CITY OF ALBUQUERQUE

**Re: La Cuentista Unit III Drainage Report and Grading Plan
Engineer's Stamp dated 4-18-08 (D10/D002A)**

LA CUENTISTA SUBDIVISION – Unit III

Worksheet for Willowleaf PI

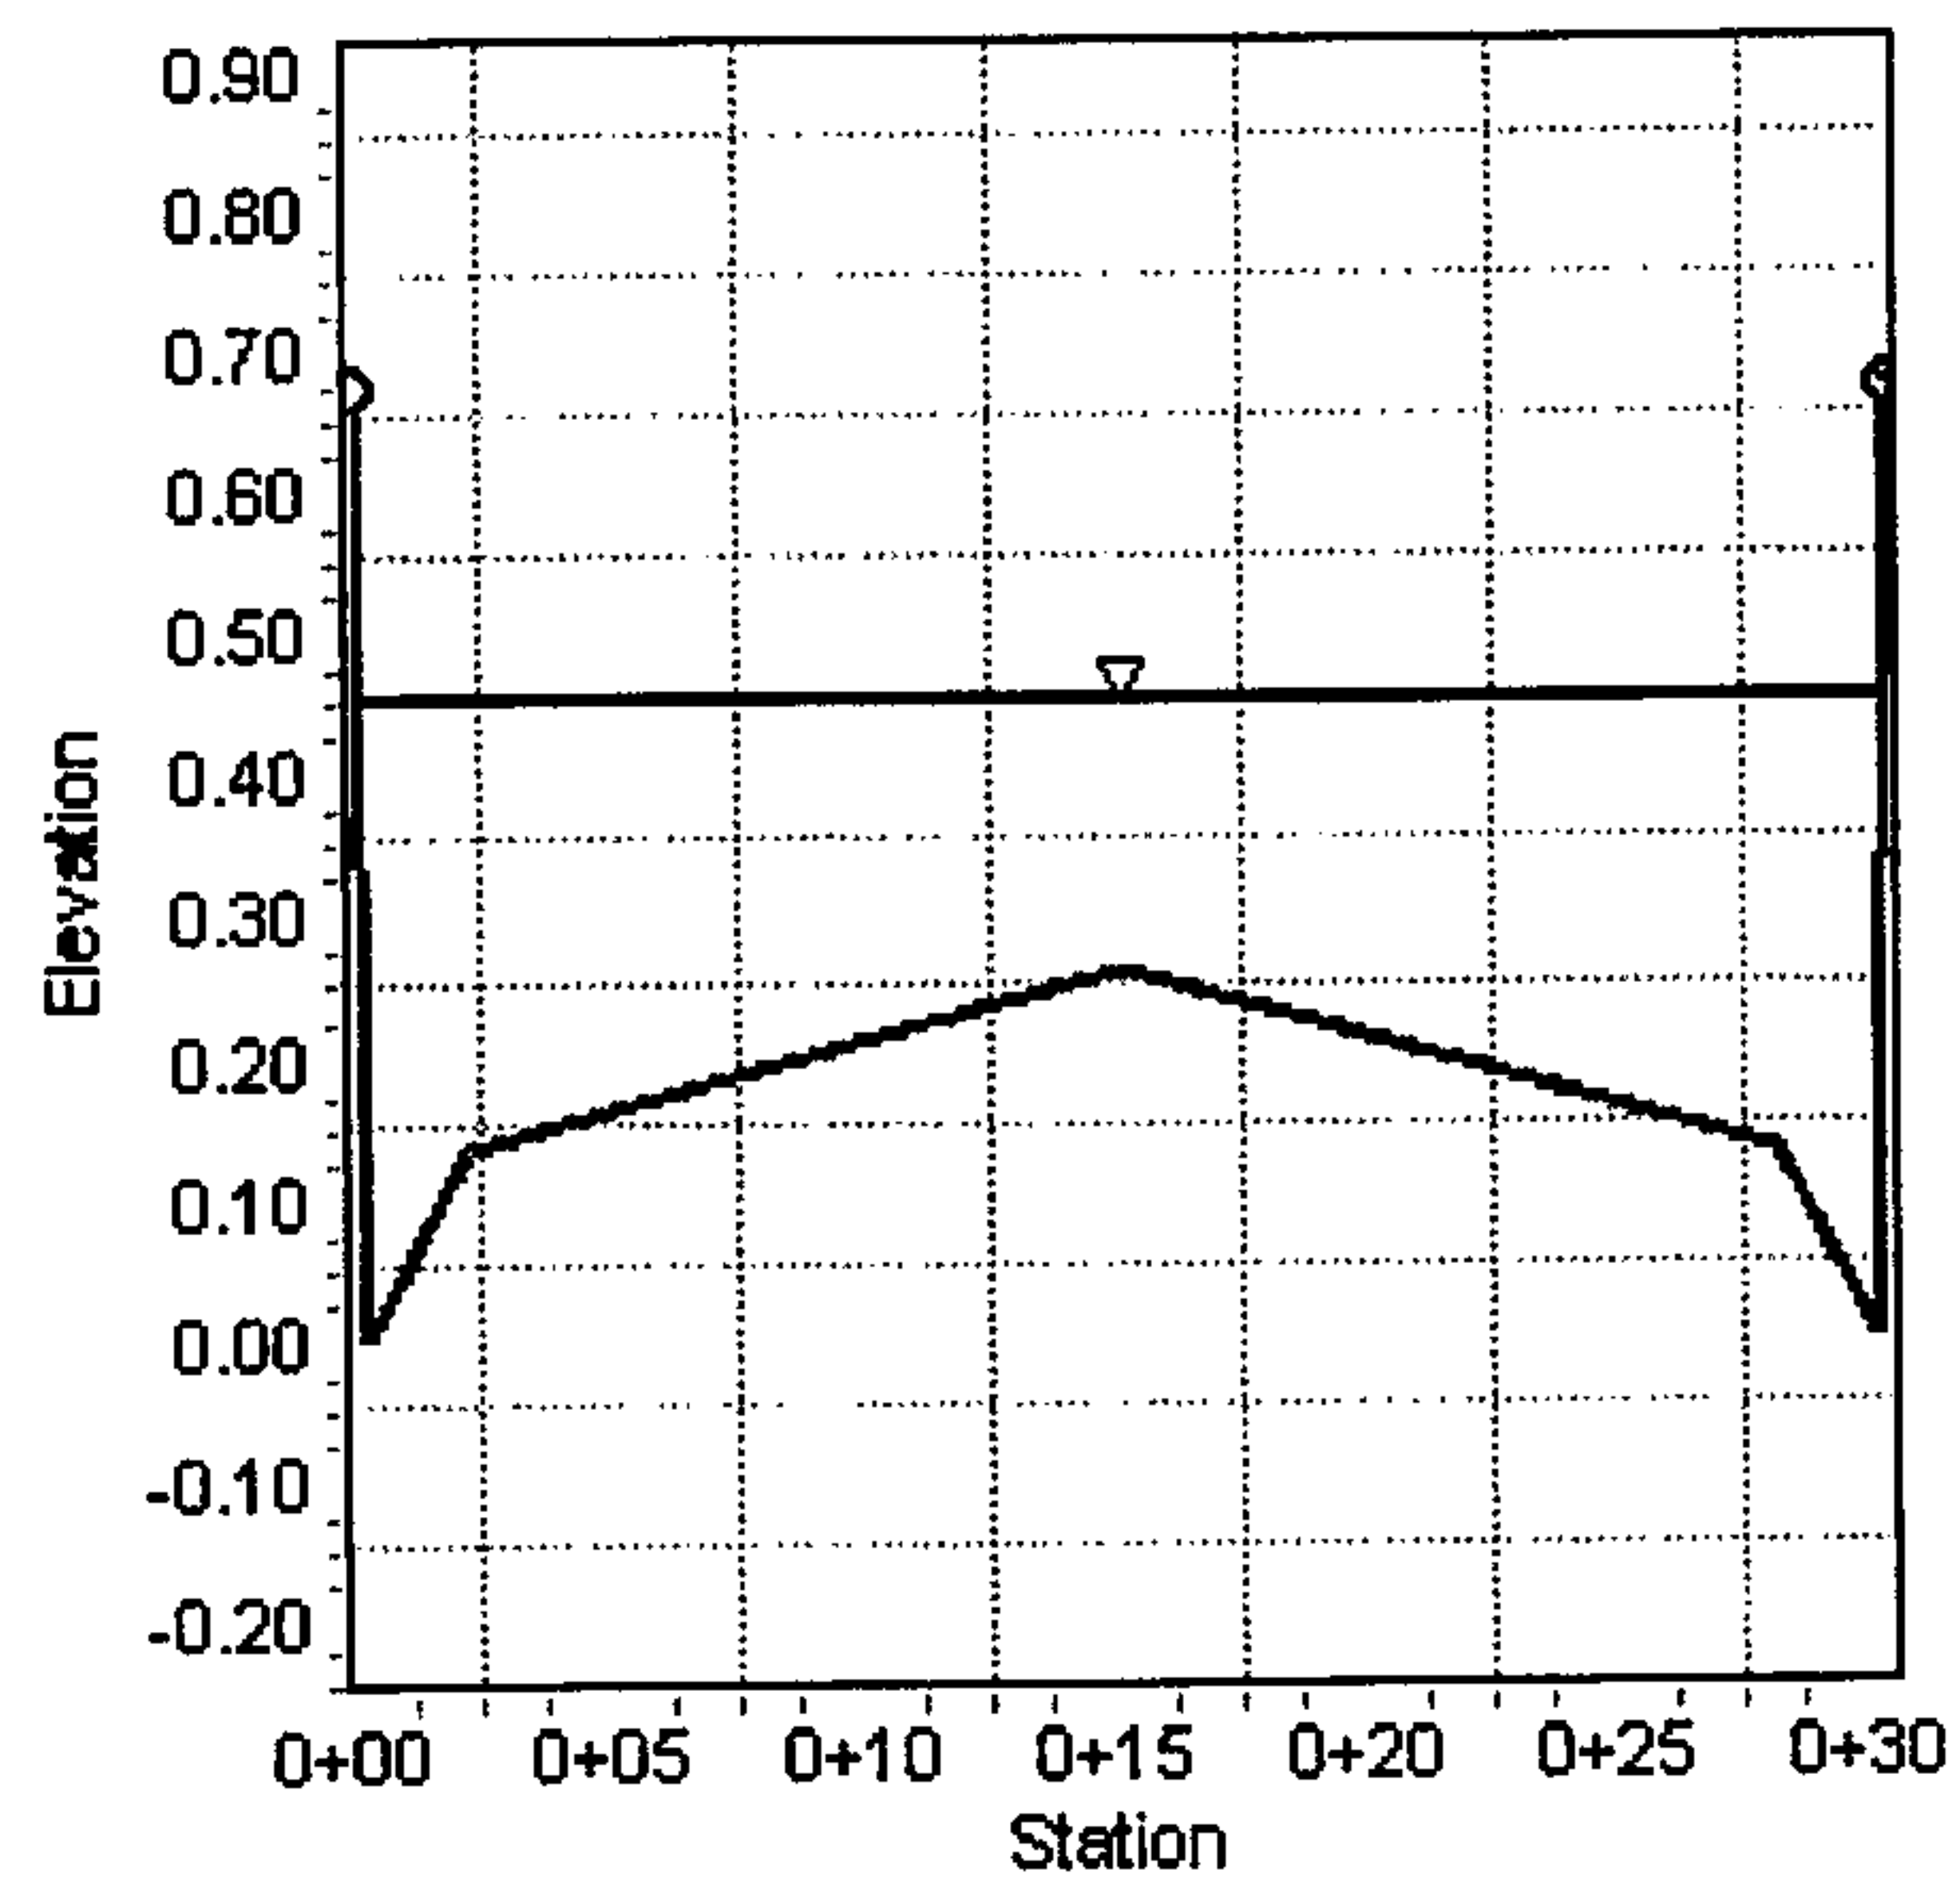
Inlets are required on Willowleaf PL to prevent runoff from leaving the street where Willowleaf PL meets Woodbine Rd.
